*Architectural Advisory Committee:  
Request for Design Review and Recommendations*

**Subject:** 433 Main Street Mixed Use Residential / Commercial PDP-20-051

Proposed Mixed-Use Project  
 Anthony Uccelli  
 Main St & Kelly Ave  
 Half Moon Bay, CA

Proposed Site Plan  
Ground Level

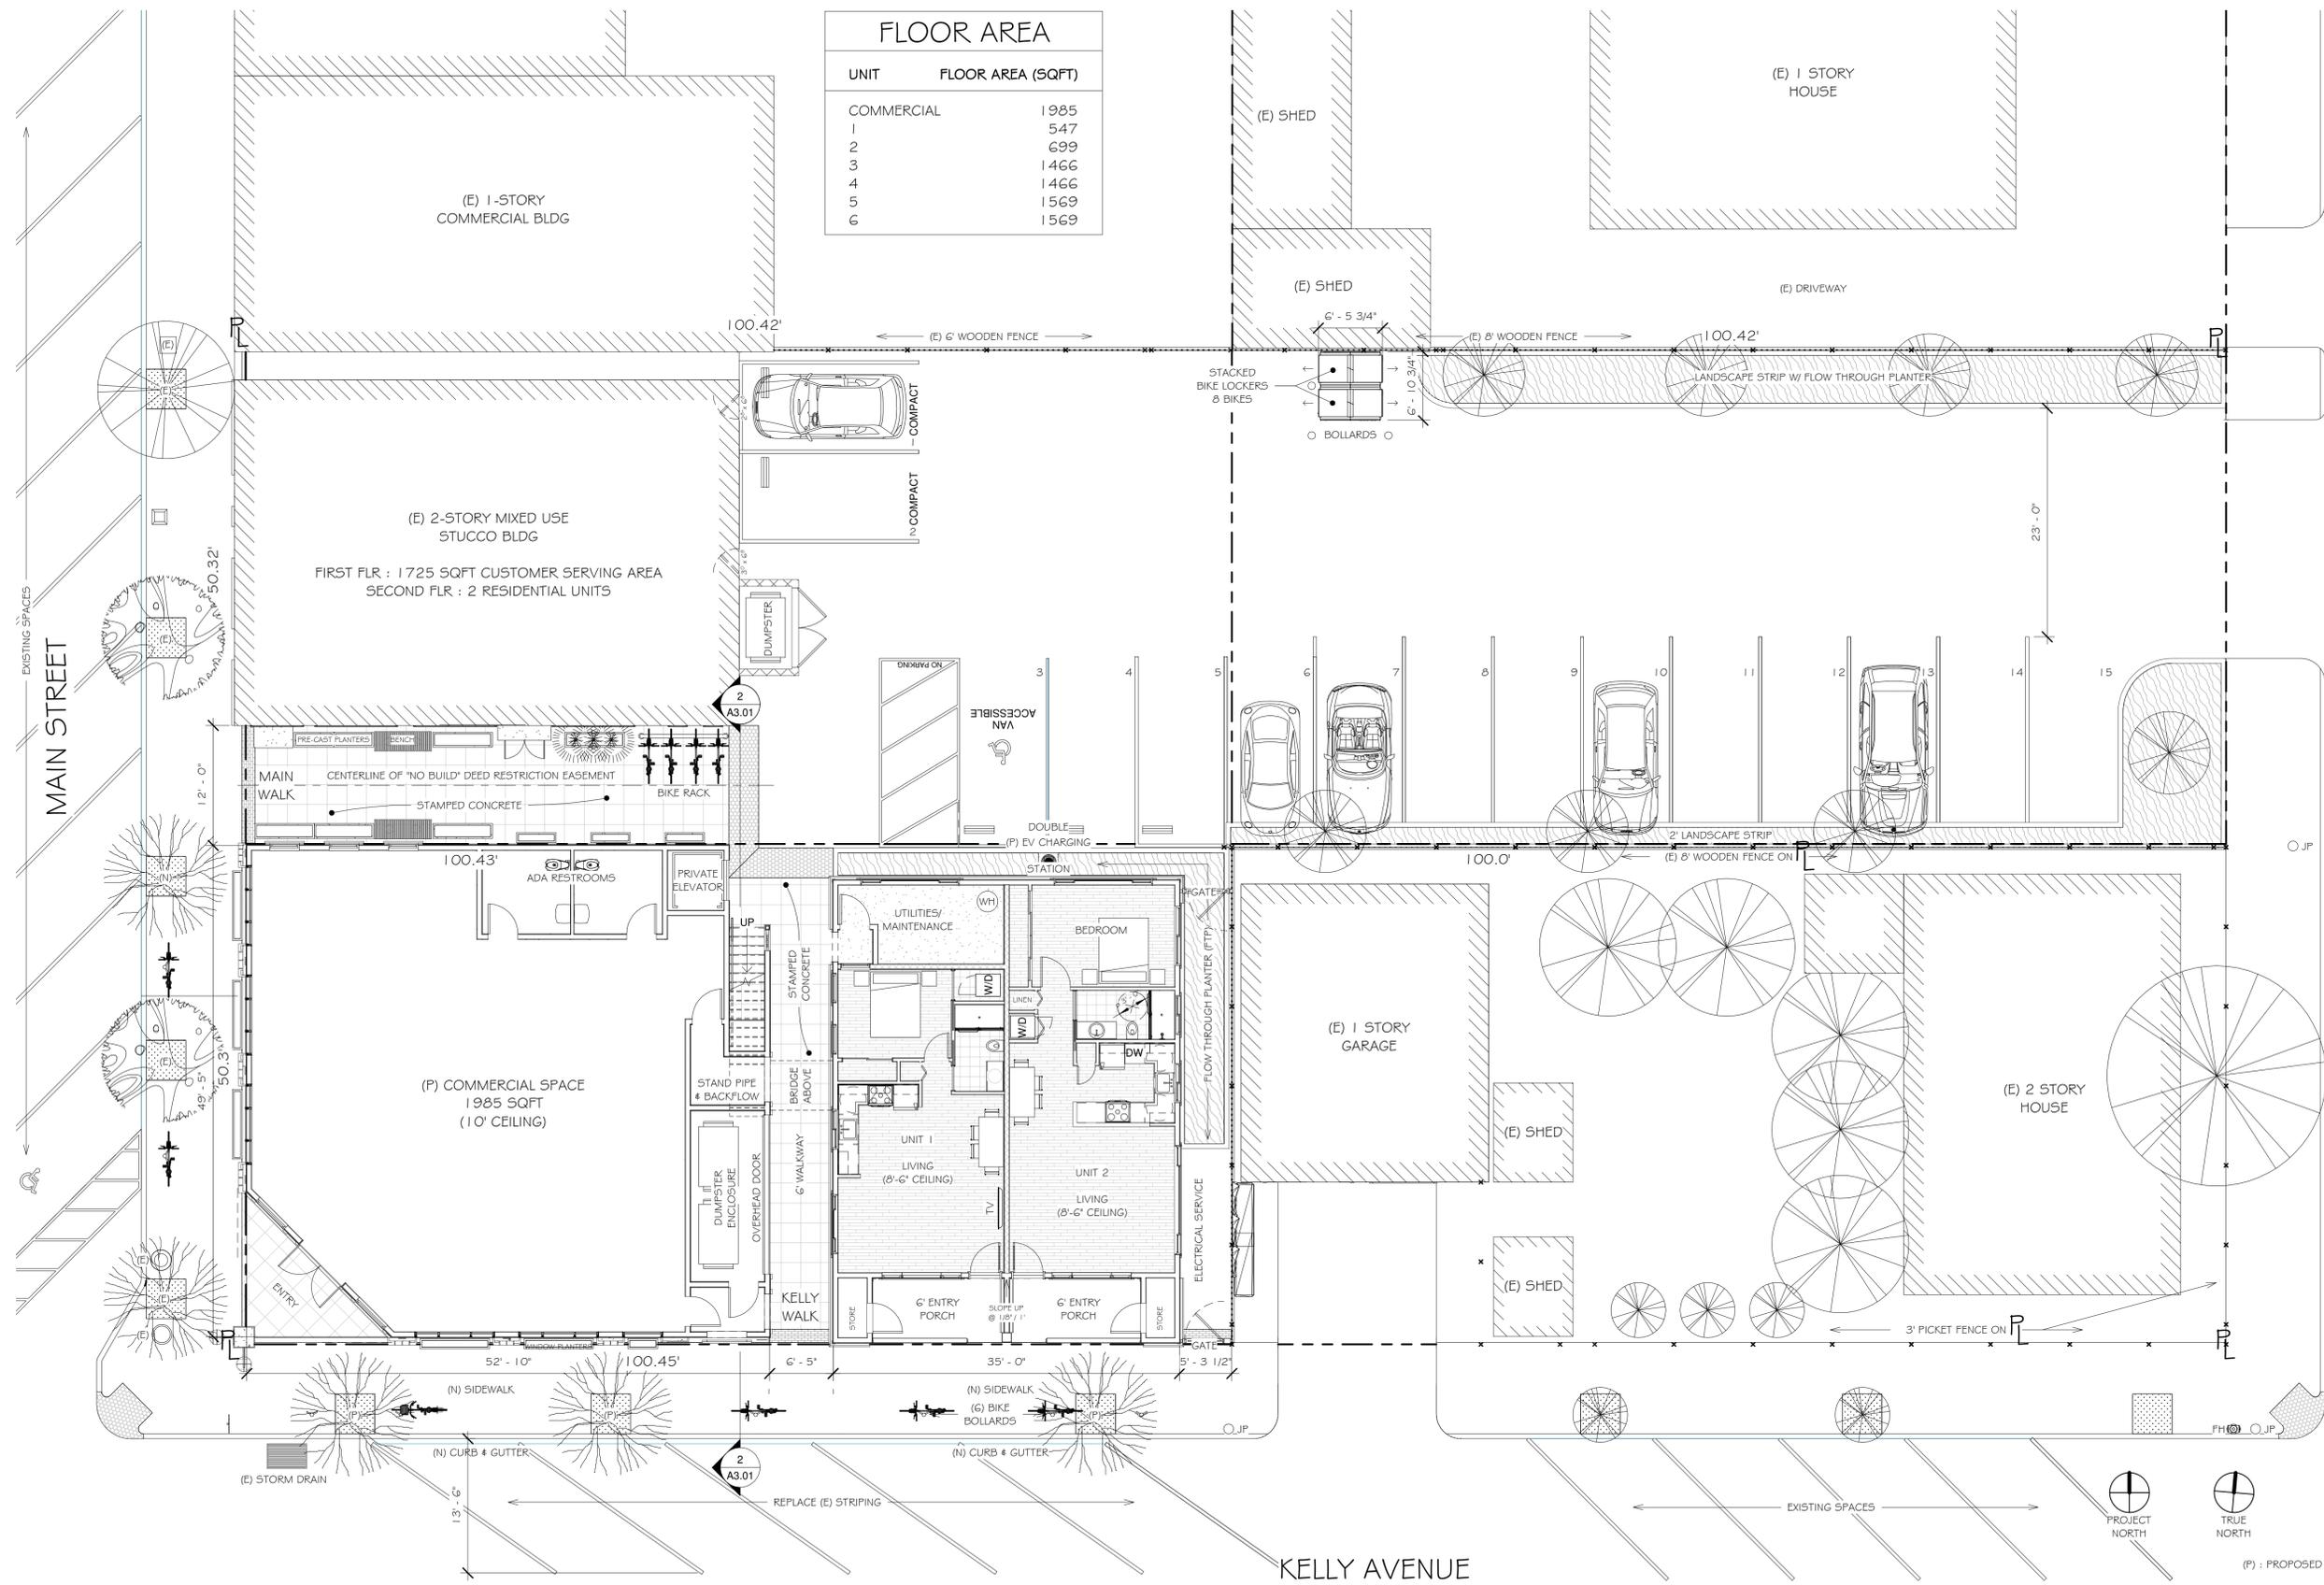
Bike Parking: There is a conflict between the two-way bicycle lockers and the van accessible parking space; consider other locations for the bicycle lockers, potentially to the north side of the lot.

Parking Lot: Consider replacing the wheel stops on parking spaces 4 through 15 and replacing with landscaping/ or curb stop for the flow through storm water planter. This could free up another 2 to 3 feet of backup distance.

Dumpster: Look into relocating or consolidating the existing dumpster for the building to the north with the dumpsters for the new buildings.

- There is a conflict between the two-way bicycle lockers and the van accessible parking space,
  - Consider other locations for the bicycle lockers, potentially to the north side of the lot.

- Consider replacing the wheel stops on parking spaces 4 through 15 and replacing with landscaping/ or curb stop for the flow through storm water planter. This could free up another 2 to 3 feet of backup distance.

- Look into relocating or consolidating the existing dumpster for the building to the north with the dumpsters for the new buildings.
  - Extend concrete paving into the parking lot.

*Response:* Bike lockers are located on the north side of the lot within visual distance of the walkways between the existing building and Building #1, and between Building #1 and Building #2. The location is convenient for all property users.

*Response:* This adjustment was made to the plans.

*Response:* The open lot area behind the existing building is very constrained. The dumpster location is optimized to be serviceable, outside of any needed ADA access ways, out of the way of parking lot turning movements. An enclosure will improve its appearance.

Roof Plan

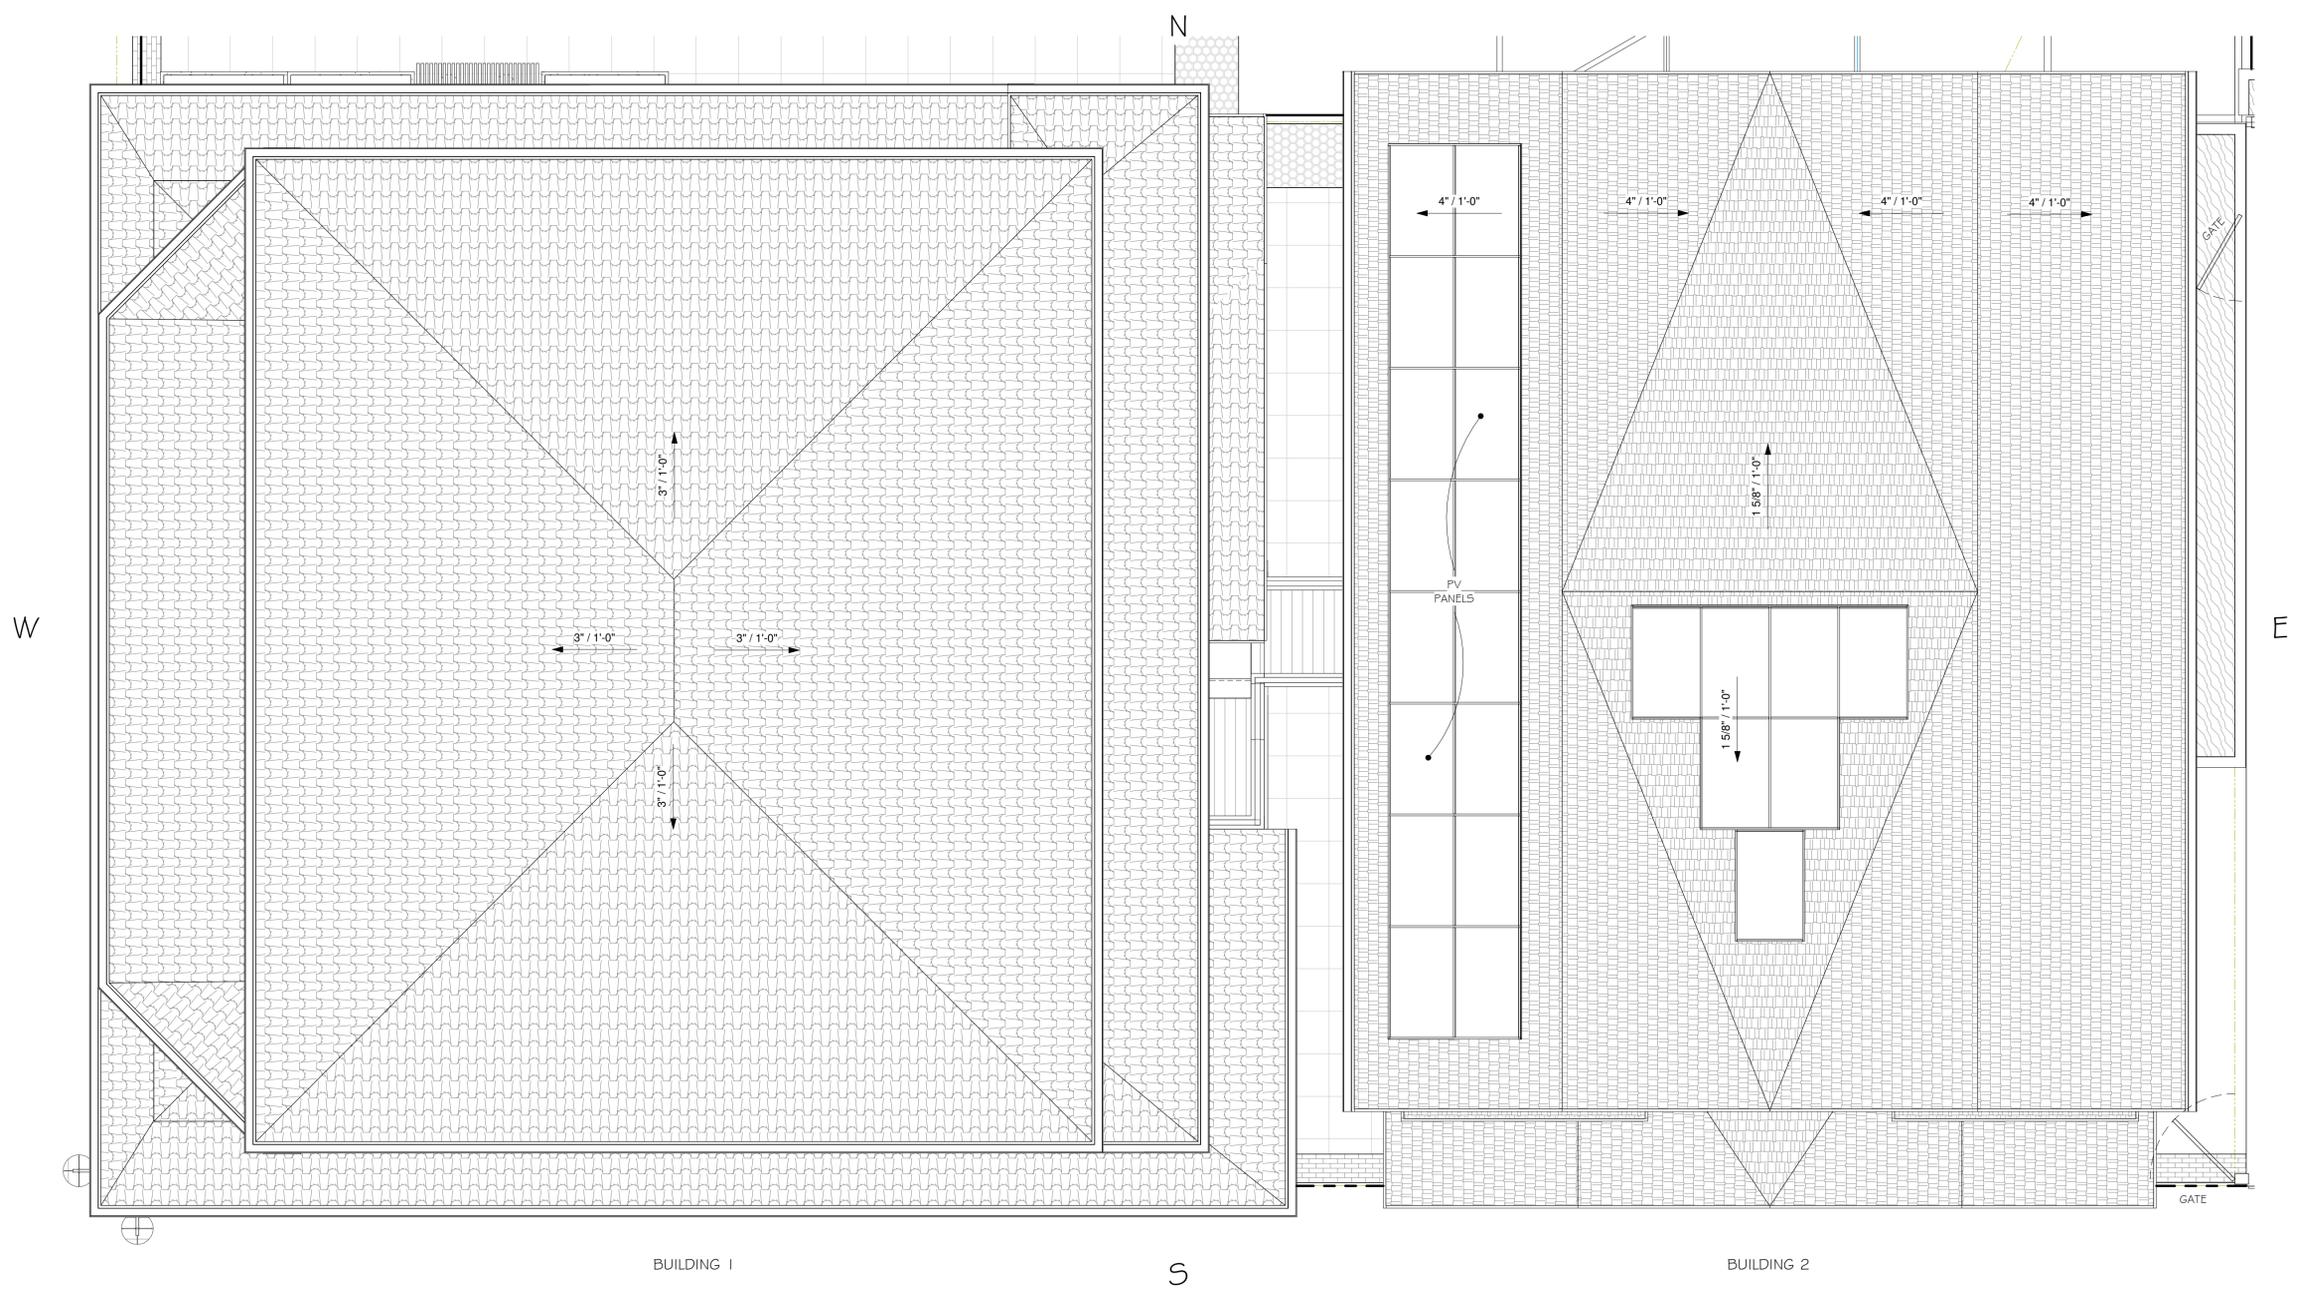
The updated plans respond to the AAC's input from the September 16, 2021 meeting. In addition to addressing many of the AAC's comments, solar panels have been added to Building #2 in anticipation of pending City ordinance. A summary of the changes is provided below:

(23) 39" x 65" PANELS @ ~300w = 6900w

Elevations Buildings 1  
& 2 - South & North

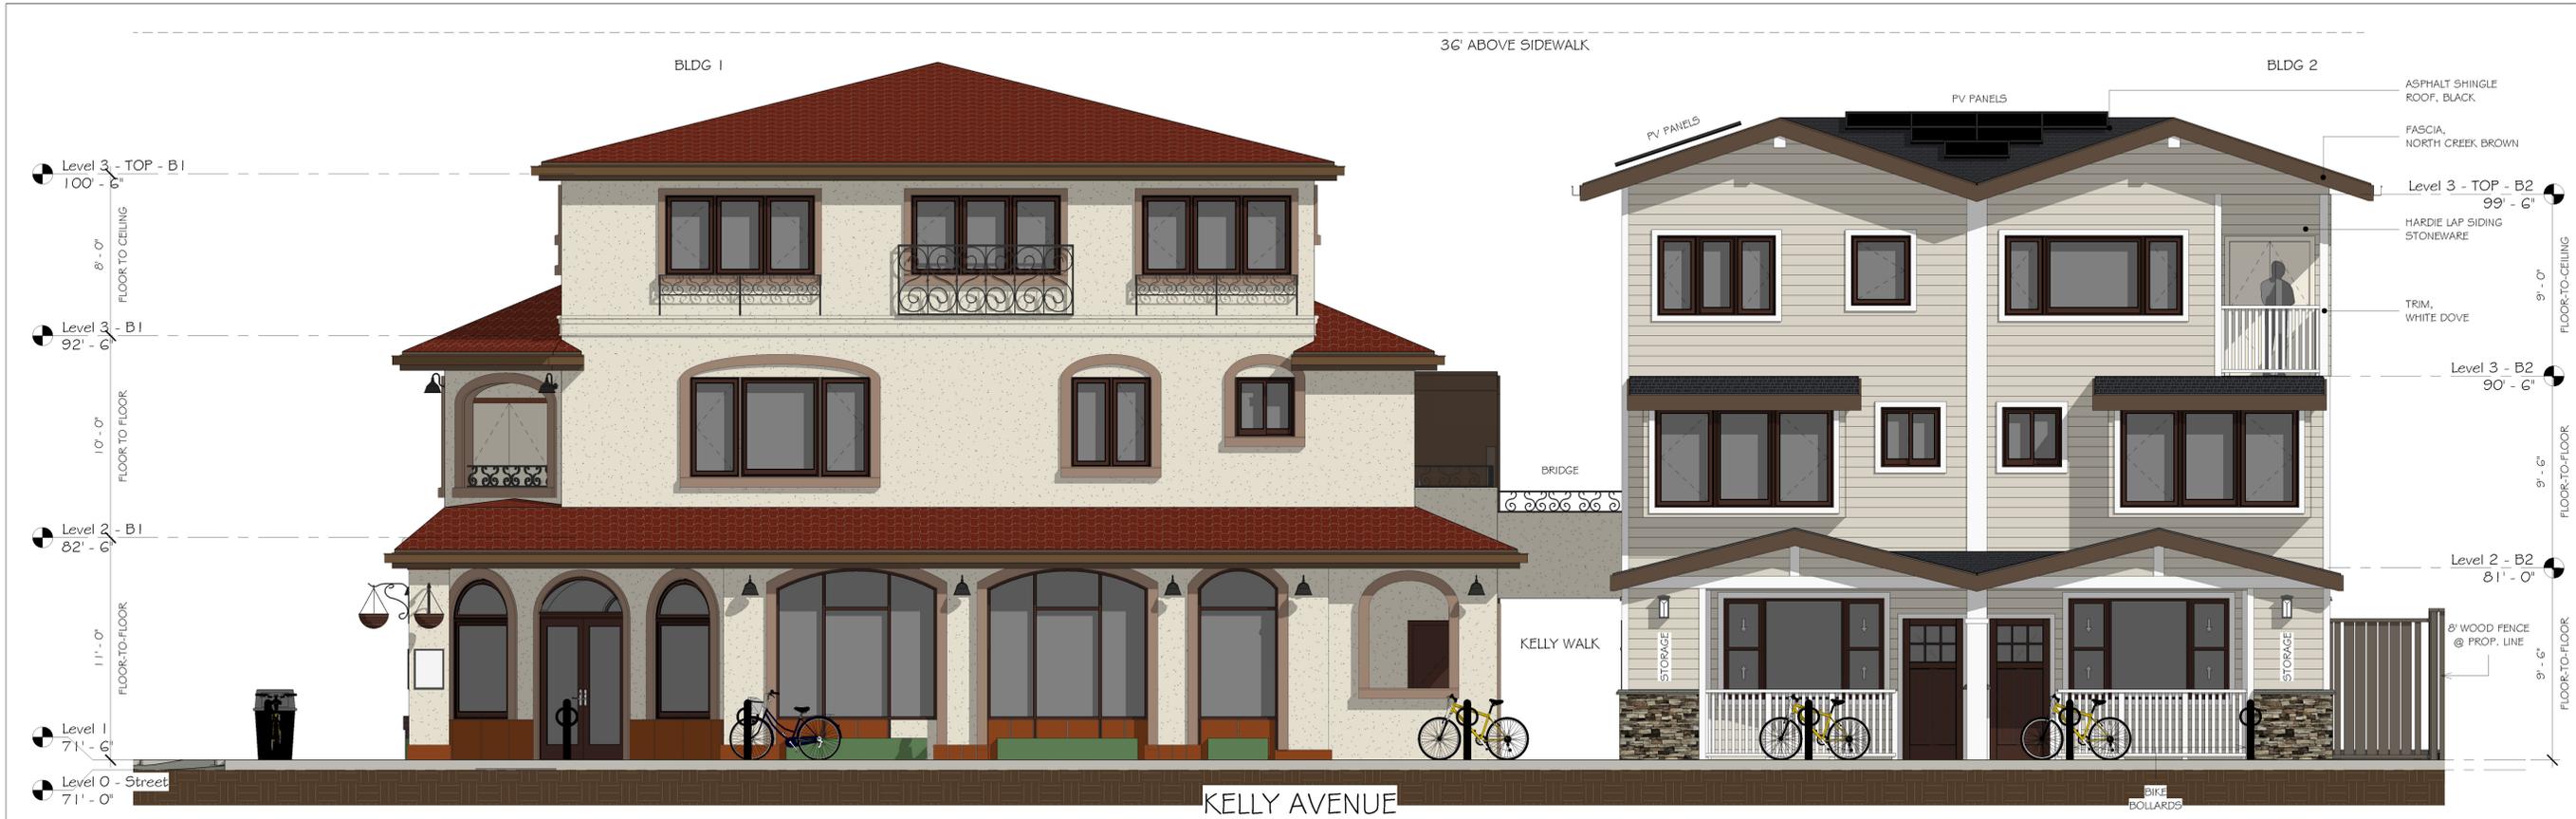
Trim Details: Add horizontal trim along the front of the cantilever on the north elevation of Building #2. Extend this trim along the remaining elevations for this building.

- The building separation between the corner building and Building#2 along the Kelly Walkway seems too close. Does this meet building code?
    - Add horizontal trim along the front of the cantilever on the north elevation of Building #2. Extend this trim along the remaining elevations for this building.

*Response:* Trim has been applied as recommended by the AAC to the north elevation, as well as to the east and west elevations.

Elevations Building 2 -  
East & West

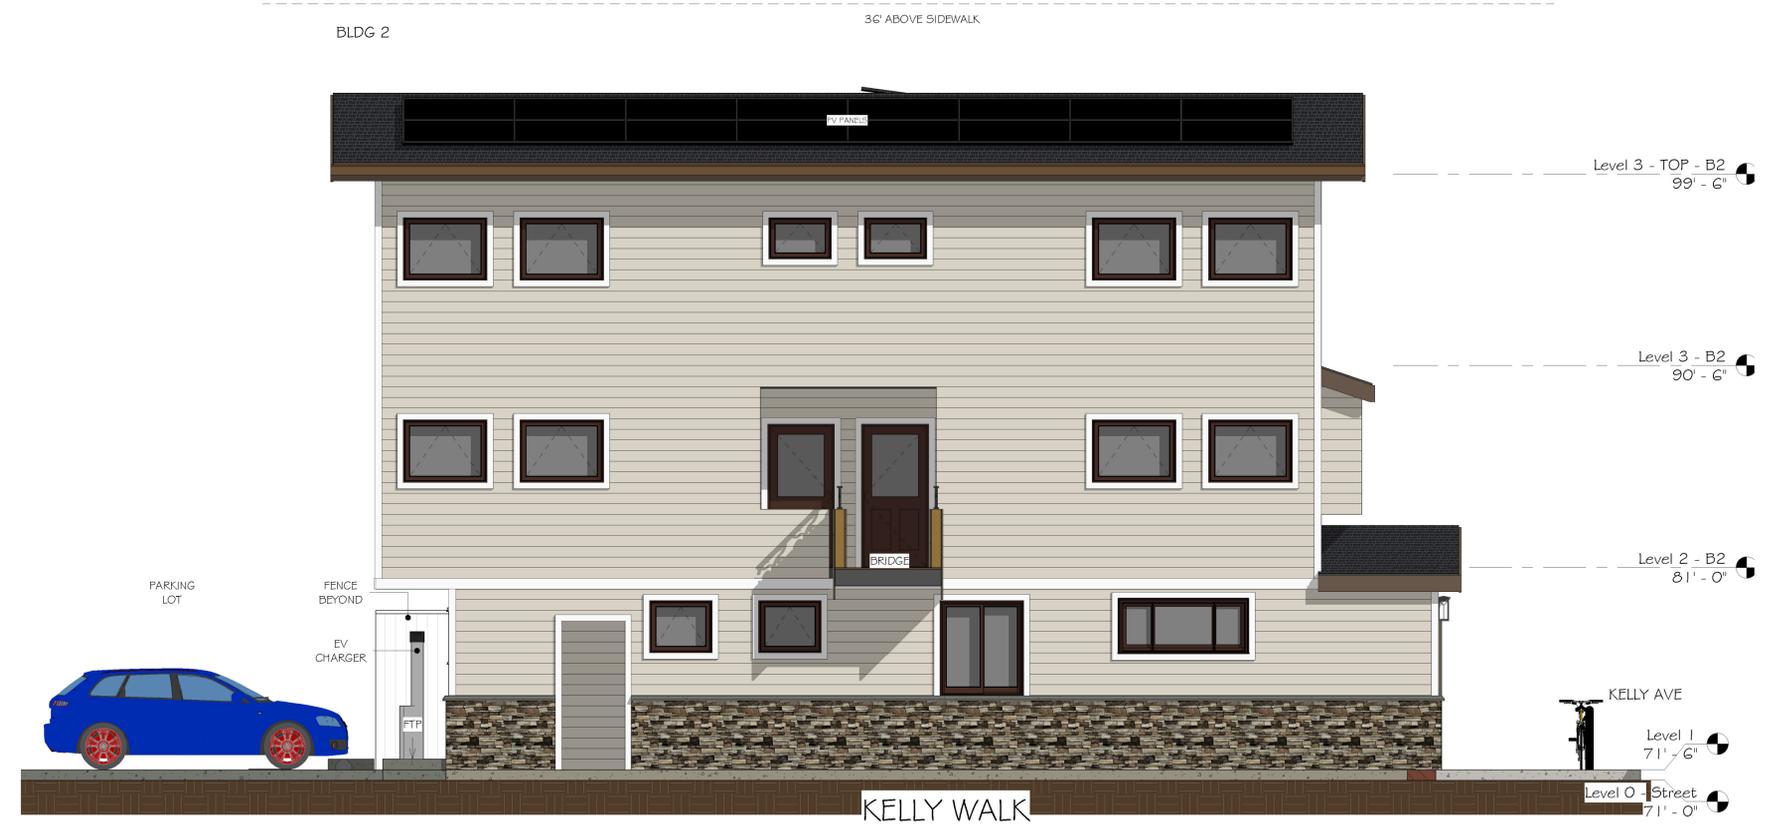
Fenestration: Expand the vertical dimension of the windows on the east elevation of Building #2.

- Expand the vertical dimension of the windows on the east elevation of Building #2.
    - Explore feasibility of extending the elevator to the third floor.

*Response:* The architect will address this comment. It is of note that storage space was added to the third-floor balcony which modestly affected this elevation, in staff opinion, in a positively.
